Model: STR-AV970X / AV1070X / D790 / D990

No. 320

Subject: No Display Due To Open R-975

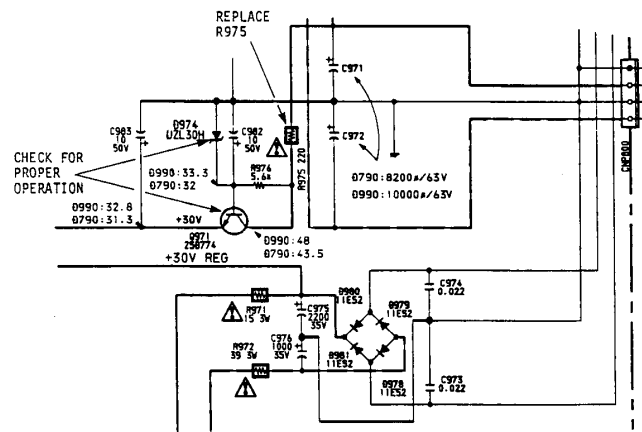
No front panel display and inactive +30 volt line due to an open circuit at R-975. R-975 opens due to excessive current. The PC board may become discolored in the area surrounding R-975 and in some cases it is necessary to replace Q-971 and D-974.

Check Q-971 and D-974 for proper operation (replace if necessary with original replacement parts) and replace R-975 with the new replacement part shown in the chart below.

REF	FORMER		NEW	
	DESCRIPTION	PART NUMBER	DESCRIPTION	PART NUMBER
R-975	CARBON 220, 5%, 1/4W	1-249-409-11	METAL FILM, 220, 5%, 1/2W	1-214-848-00
